Notes on D1.2 Comments

Ariel Maislos, Passave
Editor P2MP

Comment 52 OLT 1/2 arm

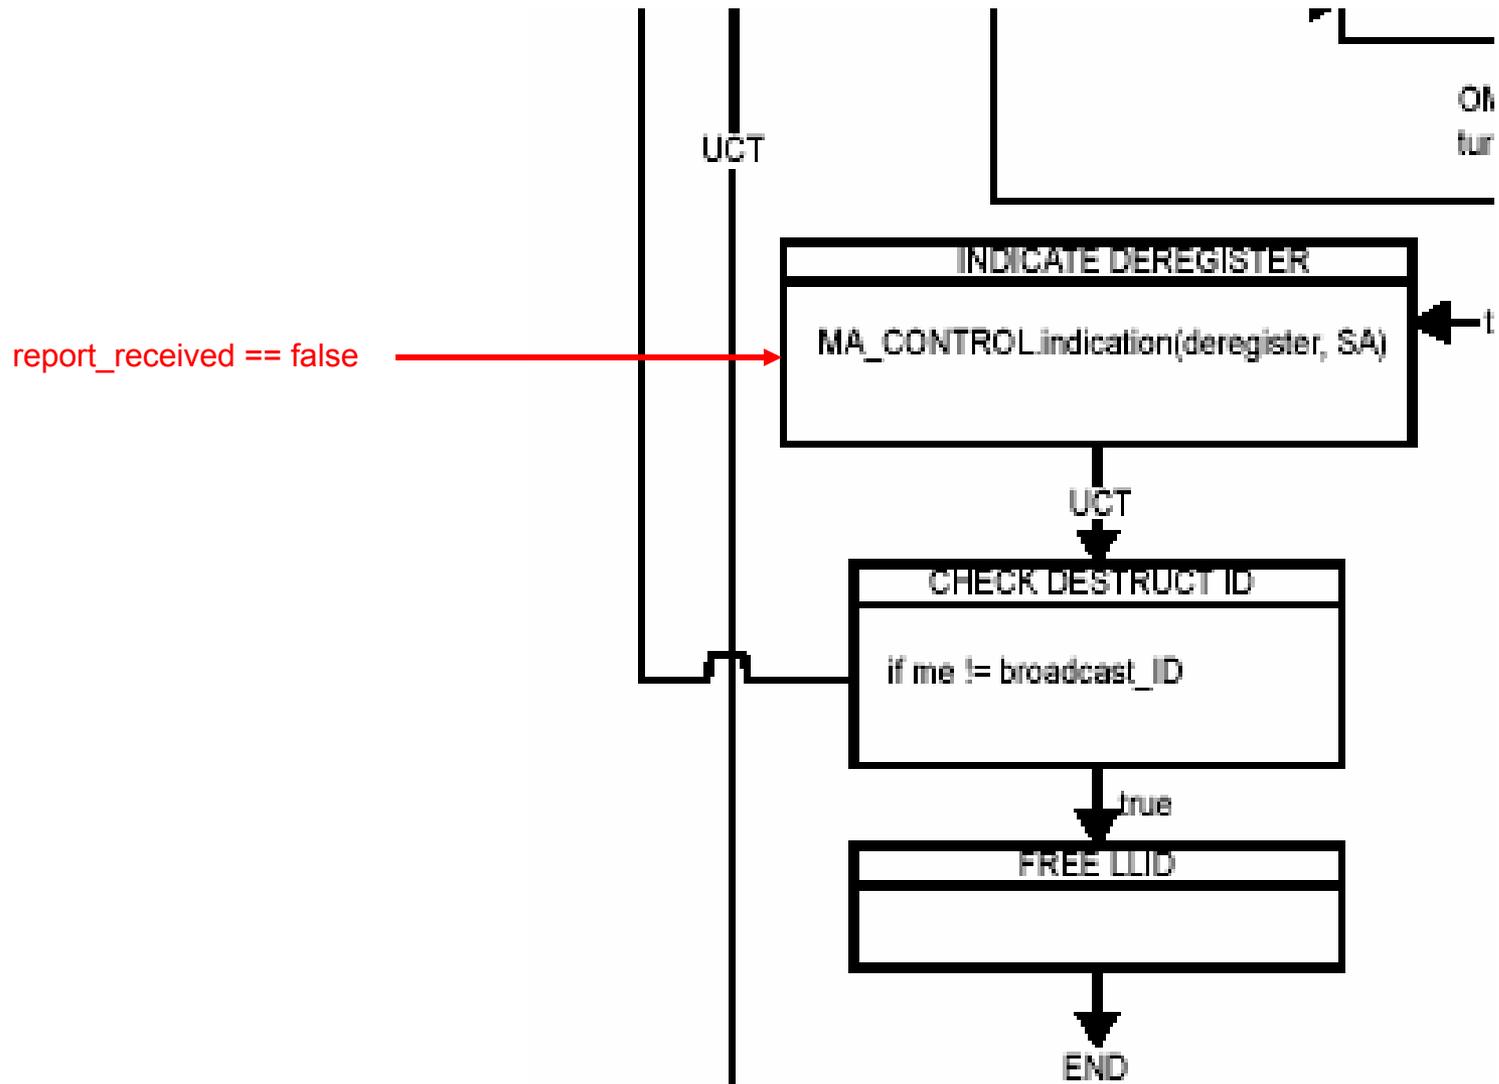
This still requires some work:

Comment 52 ONU 2/2 trigger

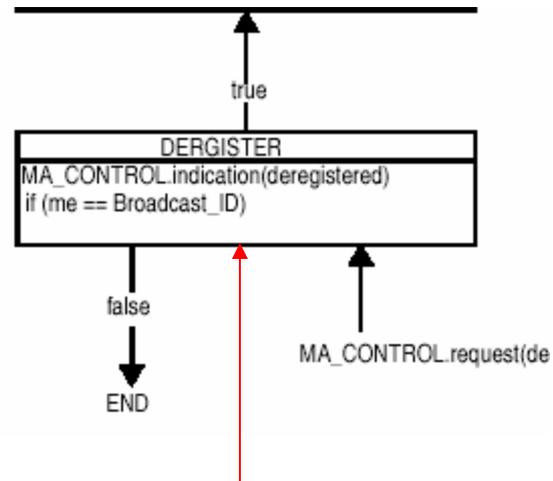
gate_recieved = false

Comment 77

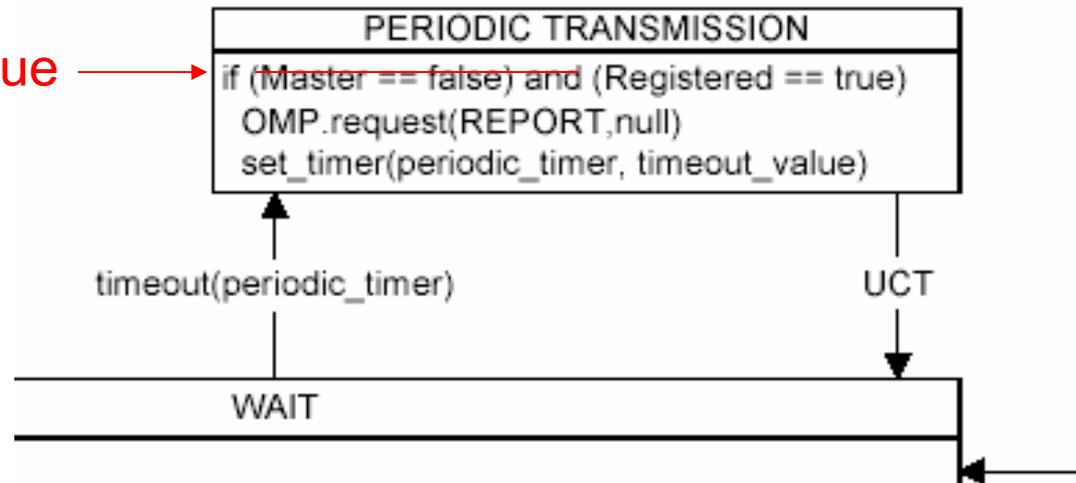
Registered == true →

Figure 56-3—Functional block diagram

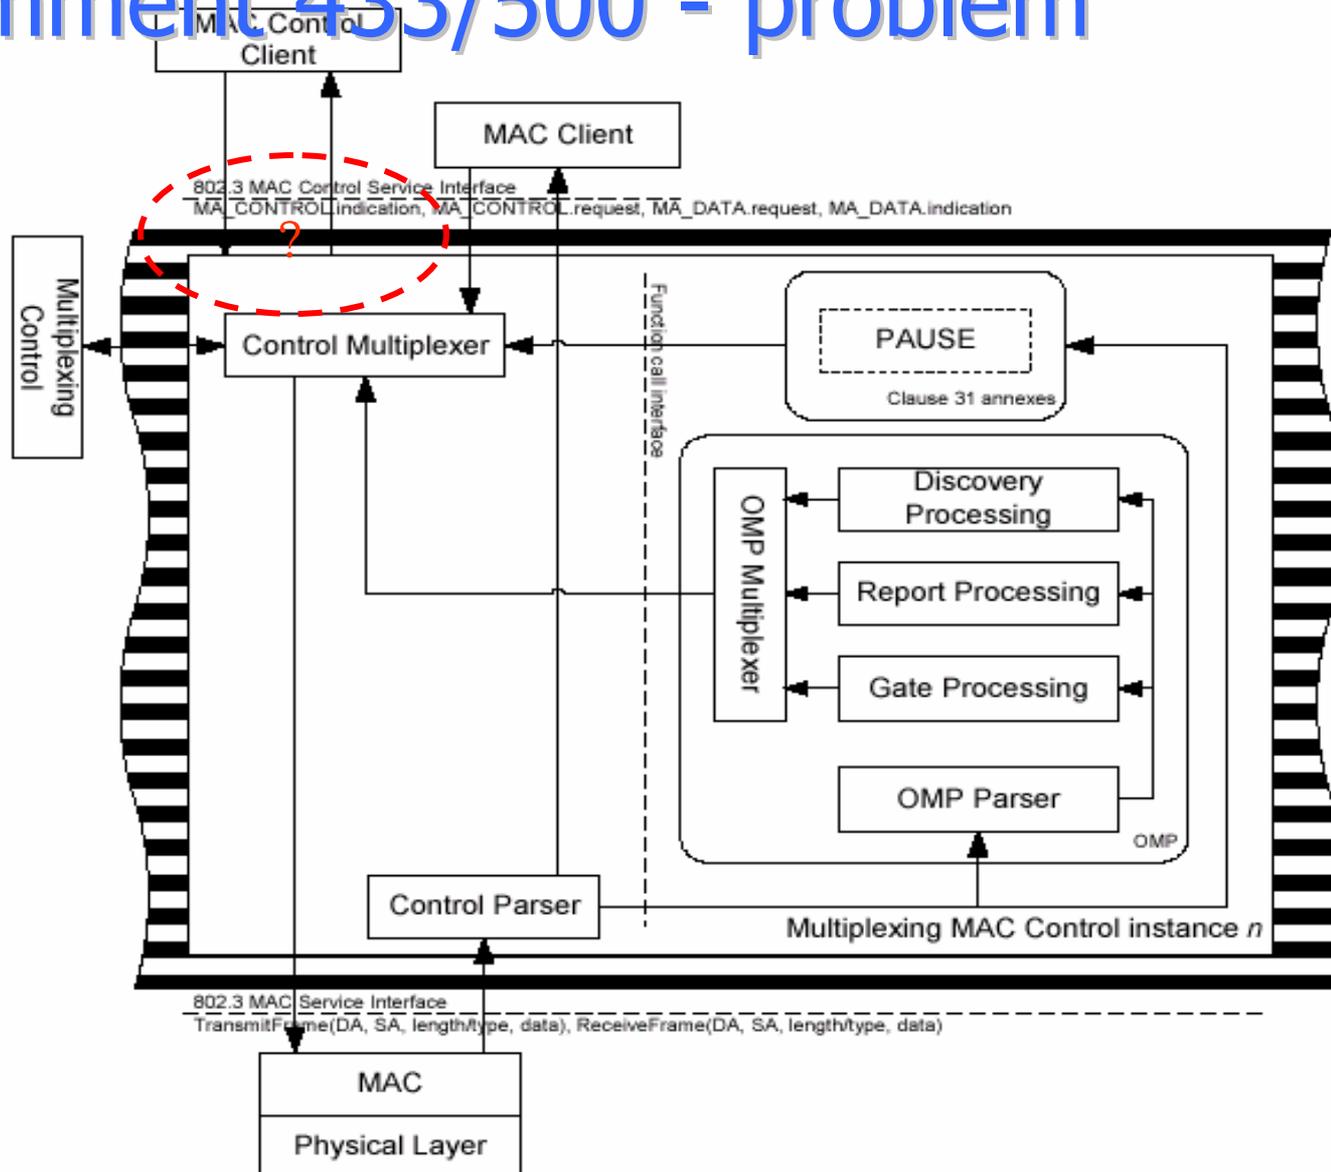
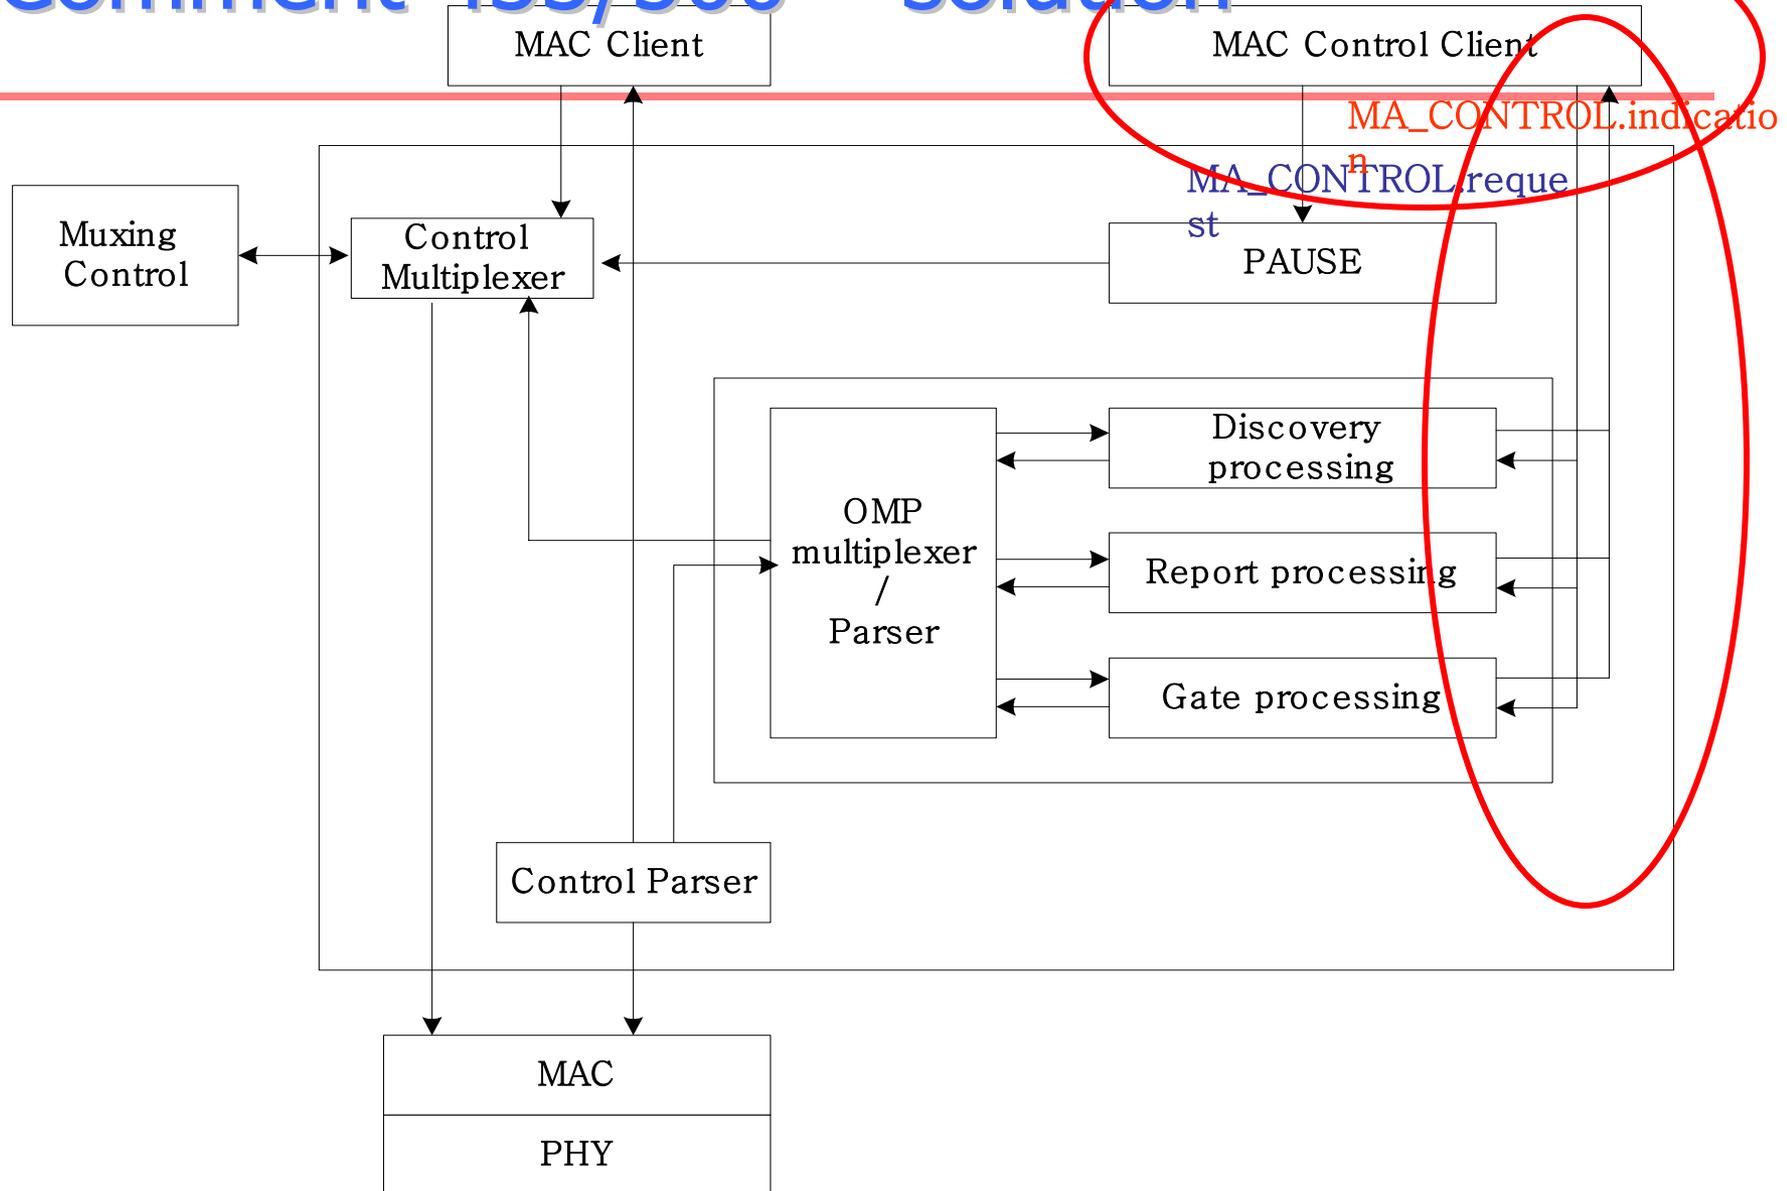
Comment 433/500 - problem

Comment 433/500 – solution
